6TH AVE RESPONSE TO COMMENTS

## **FIELD REPORT**

**Project Name:** 6<sup>th</sup> Ave Mixed Use  
**Project #:** 19344.00

6th Ave Apartment Framing Observation

**Exhibit A**

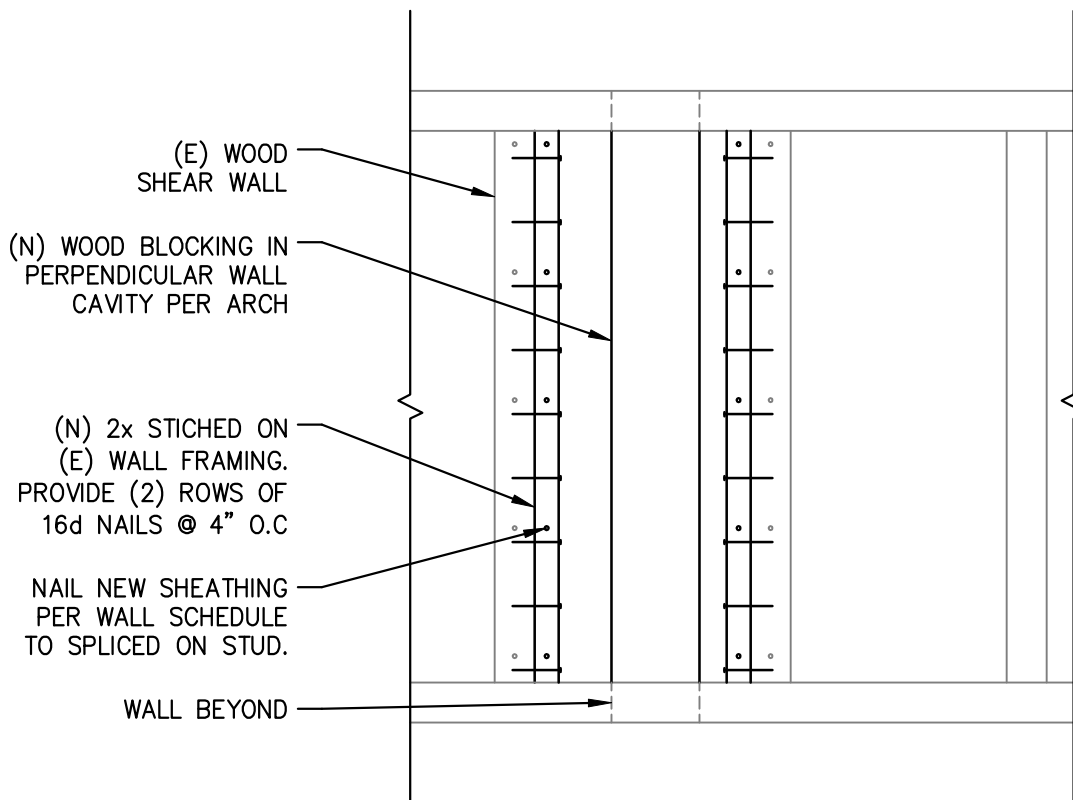
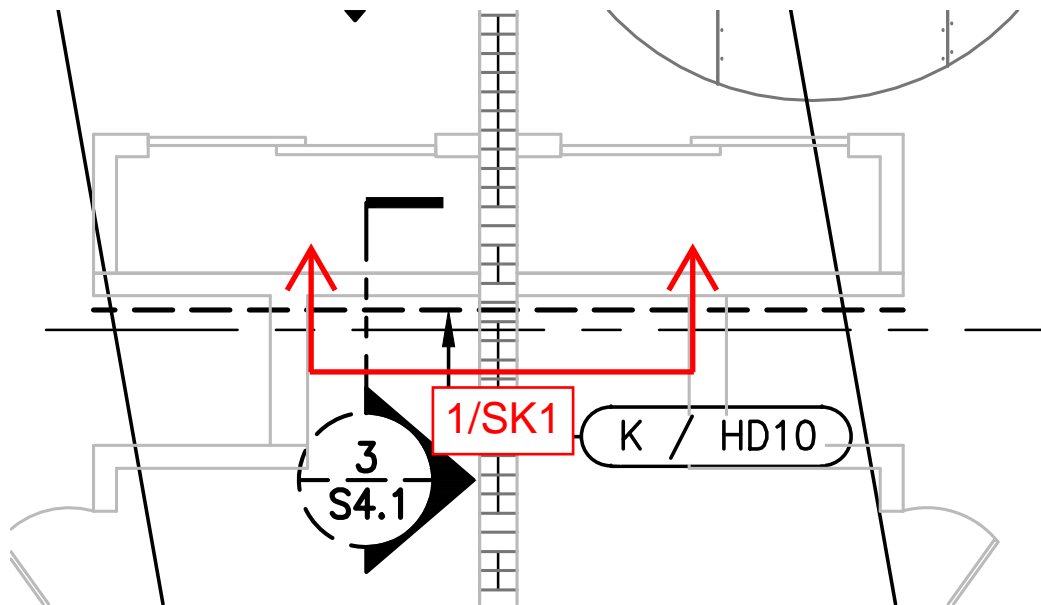
- Shear walls spanning across party walls are interrupted by the transverse wall and are required to be blocked in for fire rating. Please see Exhibit A for the required splice connection across the party wall.

**S.W SPLICE THRU PERP. WALL**

Exhibit B

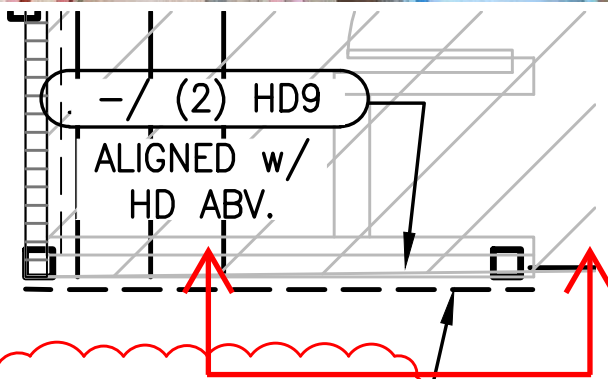
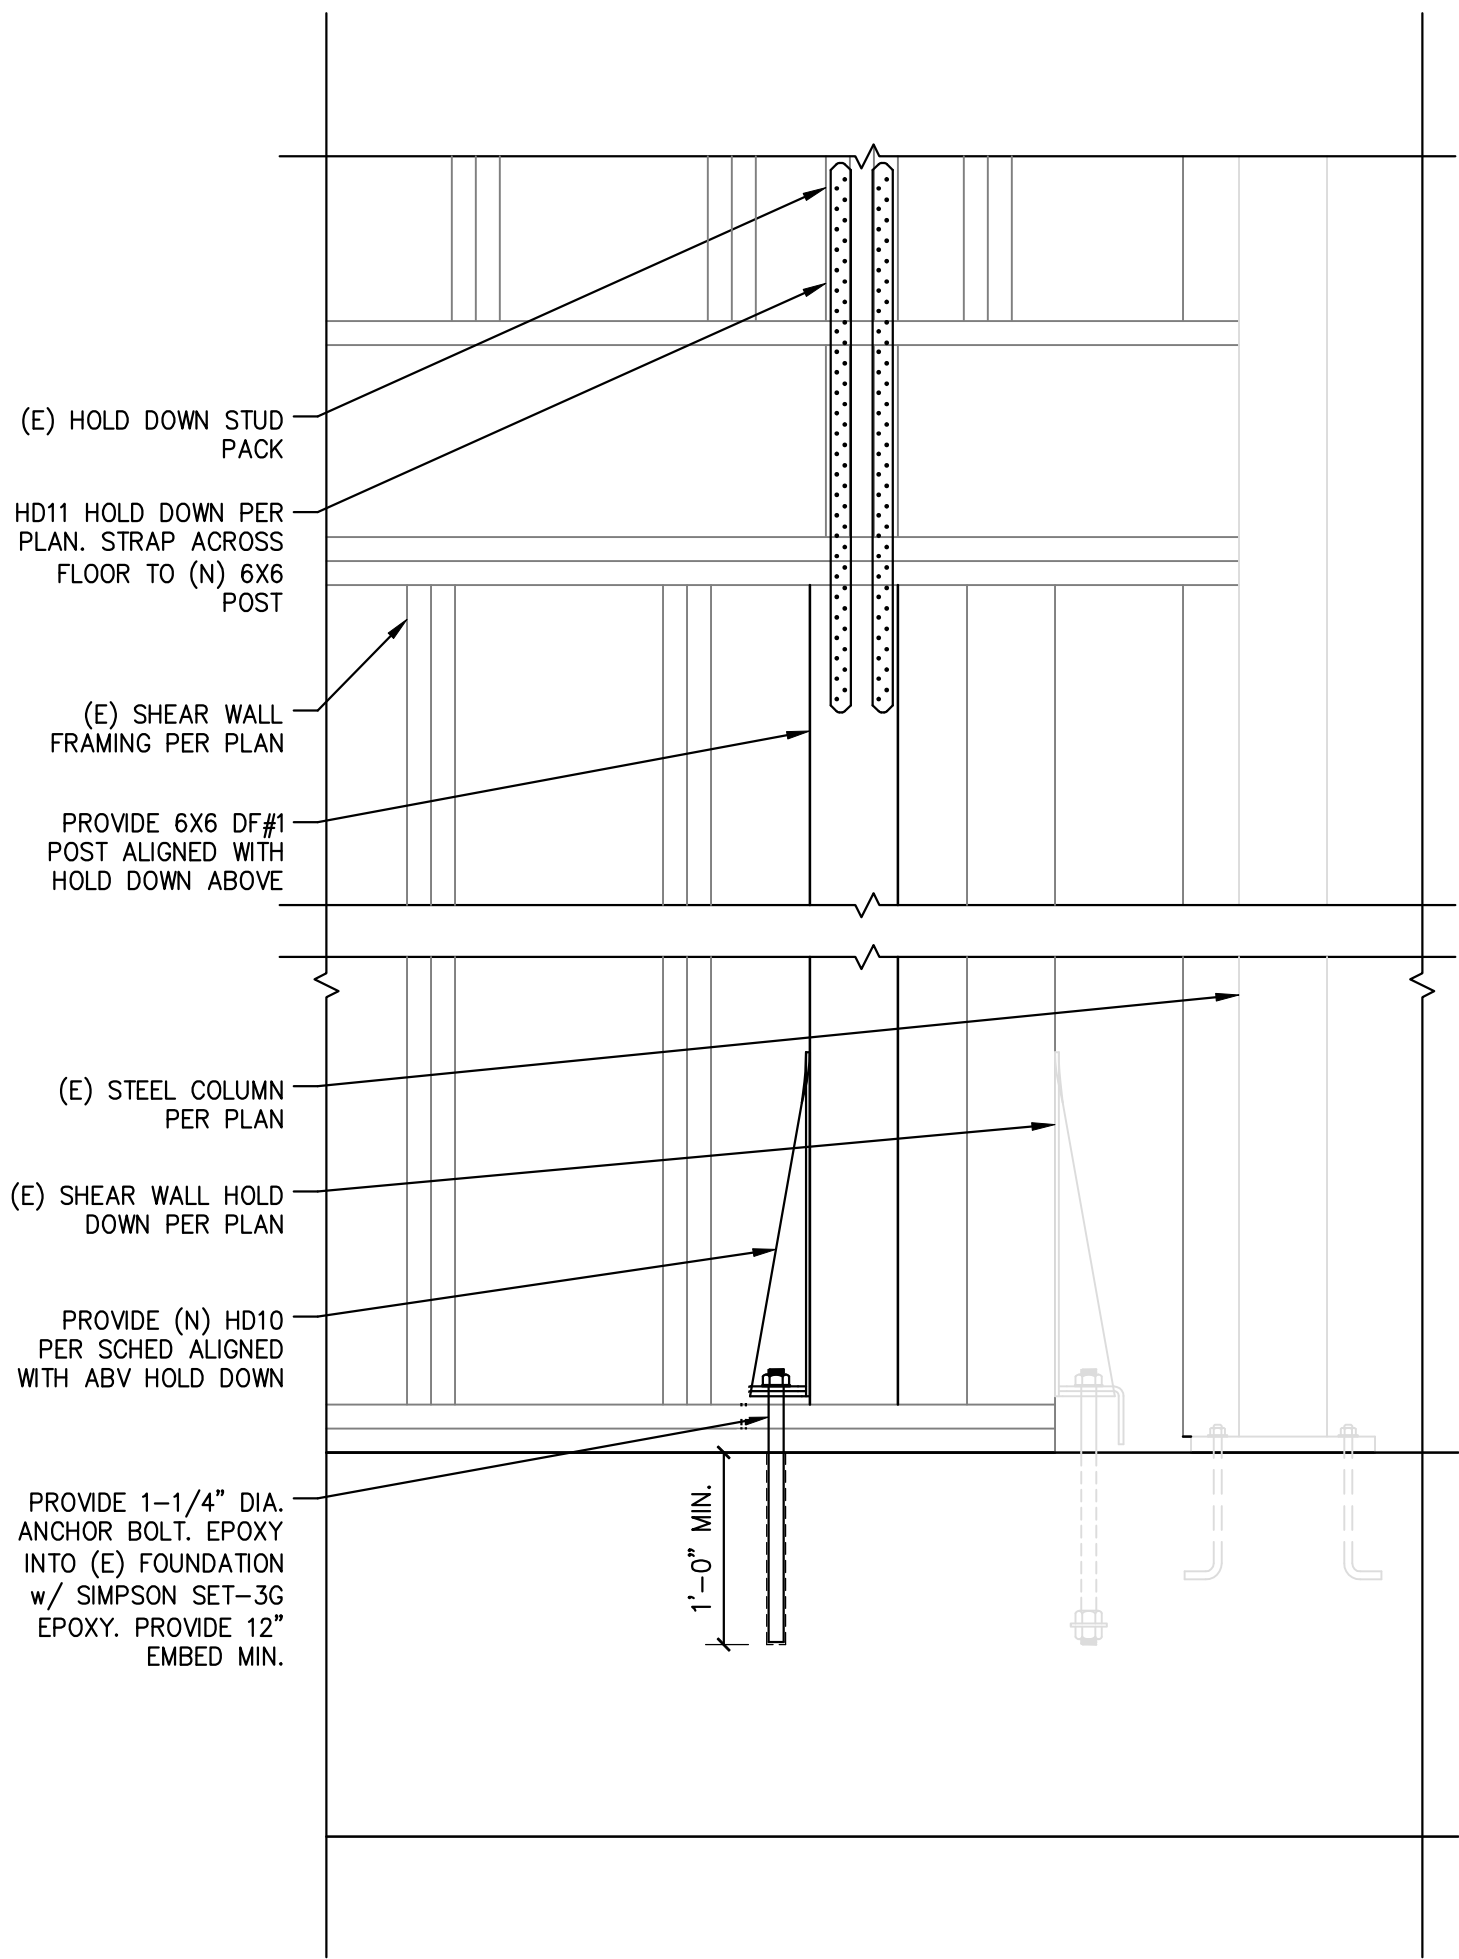
- Along Gridline I the hold down at the first floor shear wall does not align with anchor installed in the concrete. Please see Exhibit B for the required fix.

1 (N) HOLD DOWN AT GRIDLINE "I" S.W.  
SK2 1"=1'-0"

## **Exhibit C**

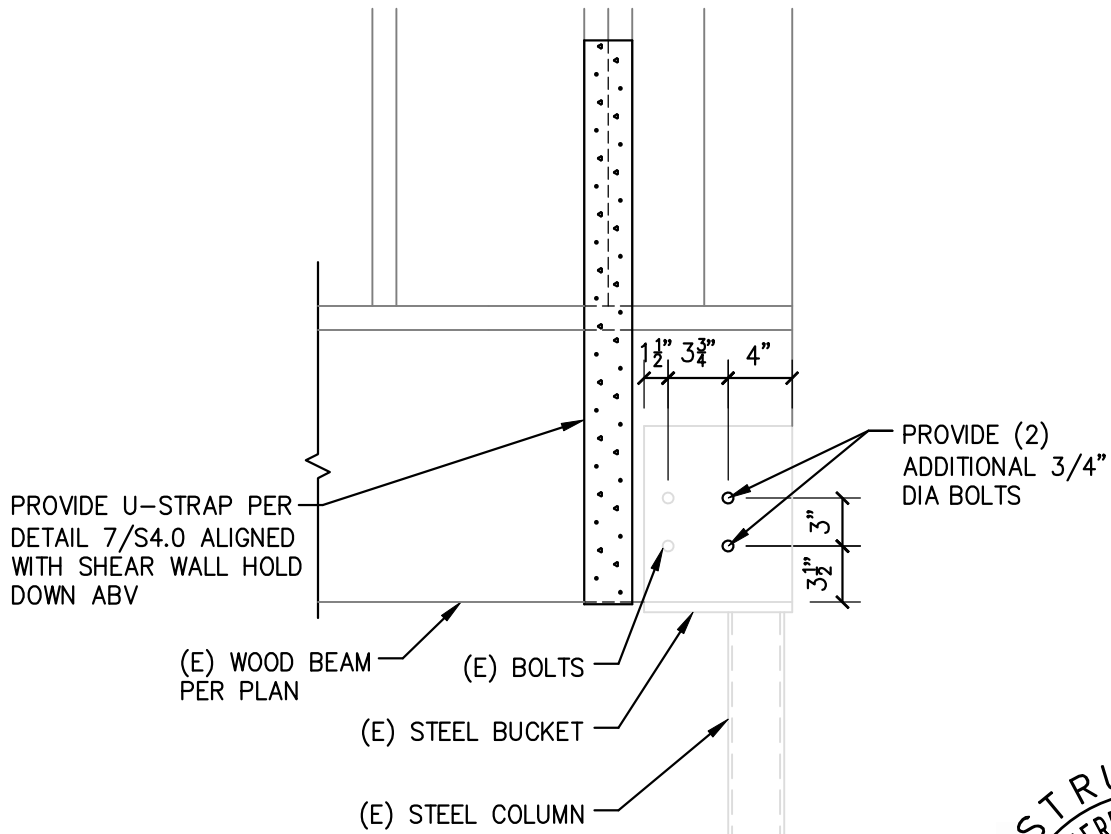
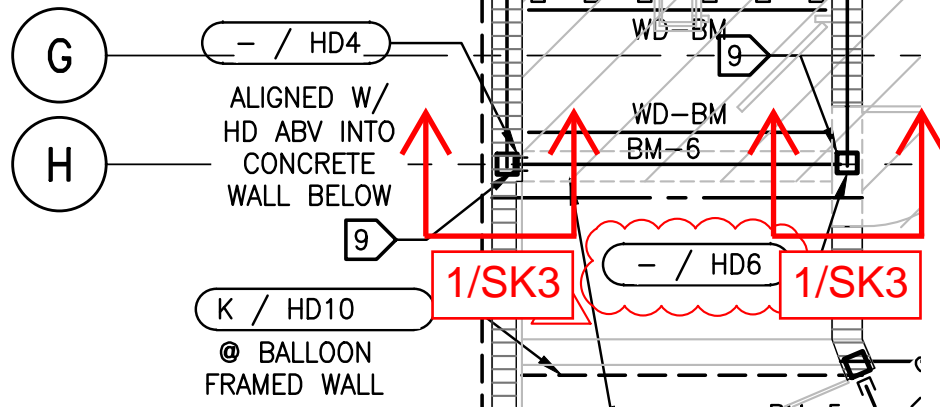
- Along Gridline H at the second floor the shear wall in the West stair wall has hold downs that are not supported by a structural member below. Please see Exhibit C for the required fix.

# 1 SK3 **BEAM BUCKET AT STEEL COLUMN** 1"=1'-0"

Exhibit D

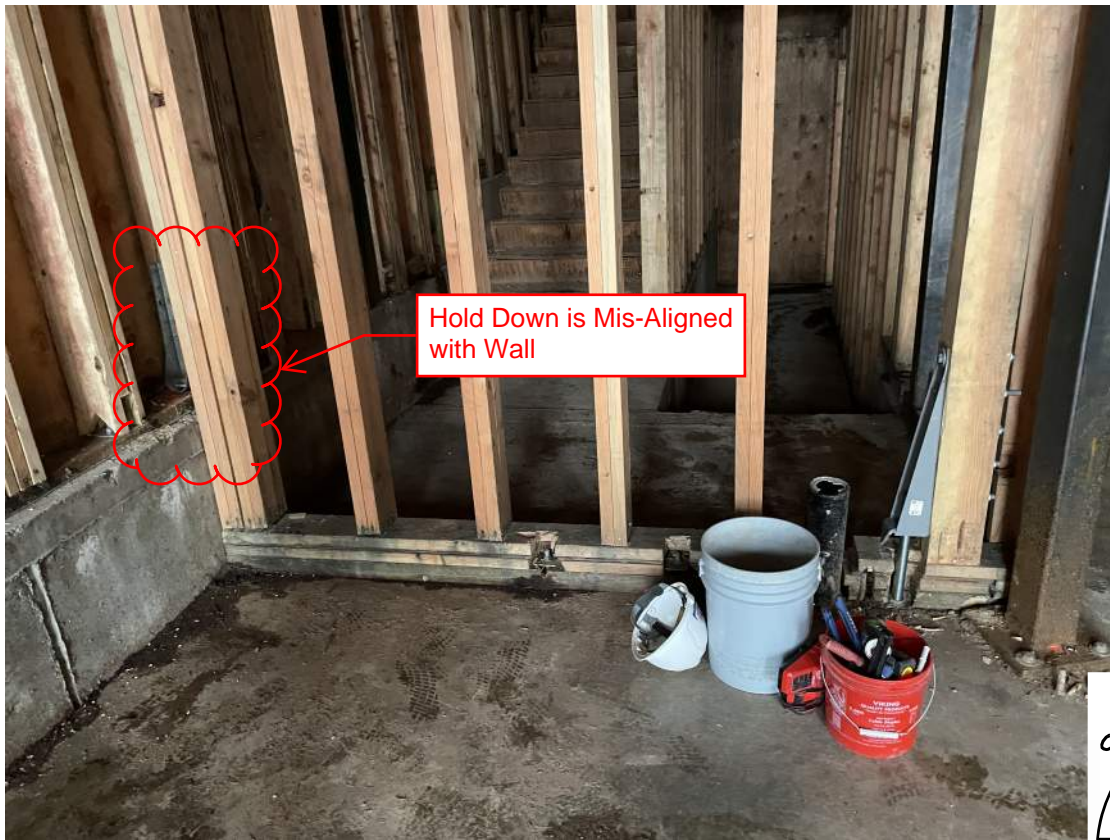
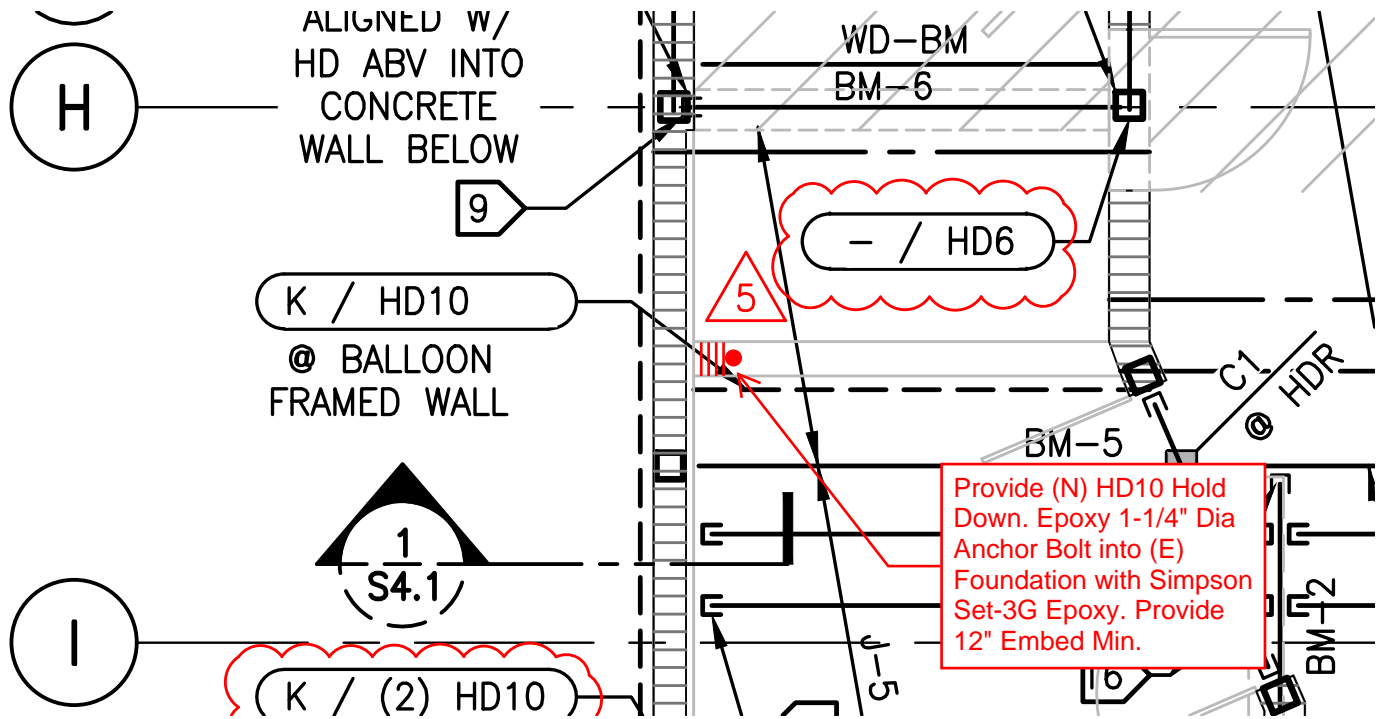
- Along Gridline H.5 on the West side of the building the shear wall hold down is mis-aligned and needs to be attached to the wall. See Exhibit D.

**Exhibit E**

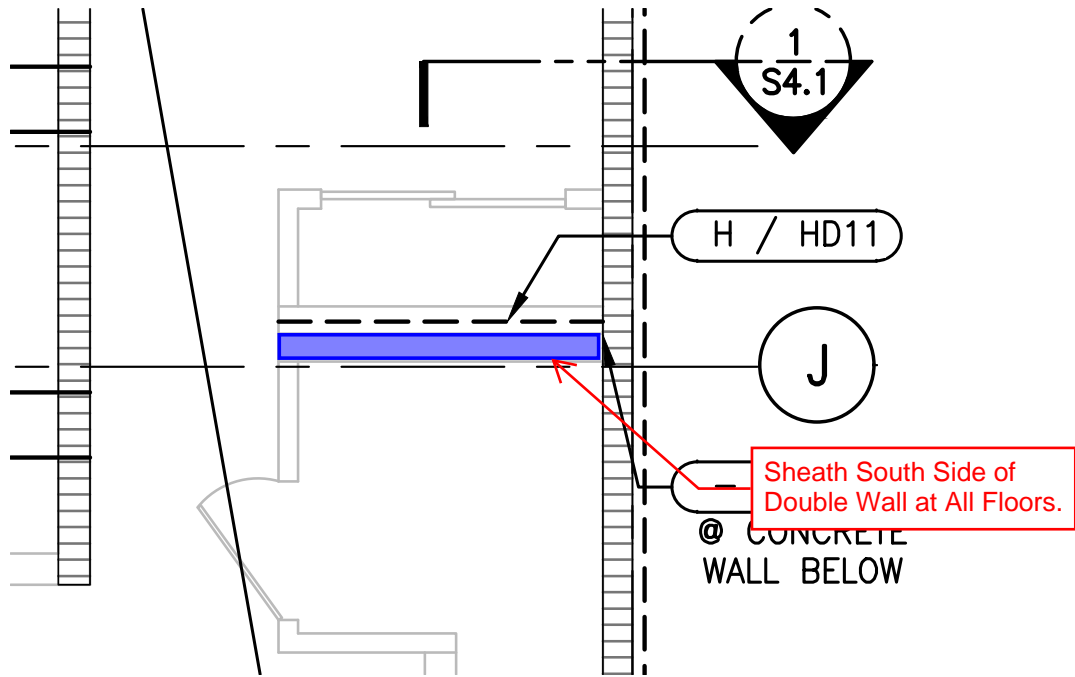
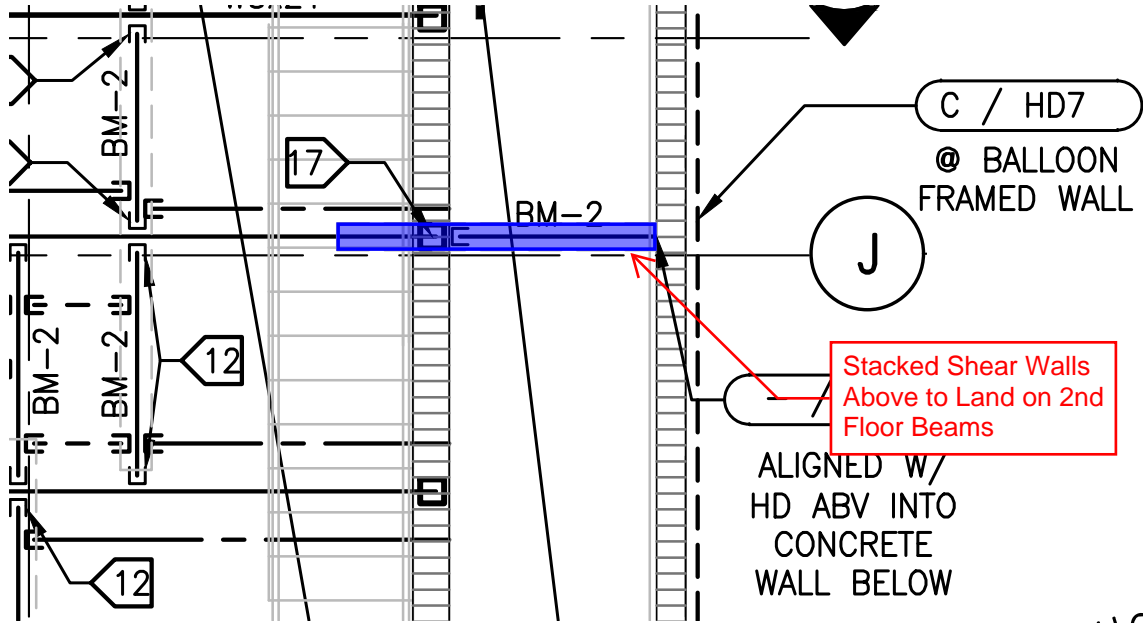
- Along Gridline J at the second floor the shear walls stacking above do not align with the beam line between Gridline 4/5. Please sheath per plan the southern wall of the double wall that is currently aligned with the 2<sup>nd</sup> floor framing beams starting at the roof all the way down. This beam is aligned with the steel column and the HD10 in the East stem wall. See Exhibit E.
- Headers above the openings along Gridline L at the brick façade are not located above the opening. Headers per plan are required to be located directly above the openings to allow for the installation of the brick lintel per Detail 15/S4.1.
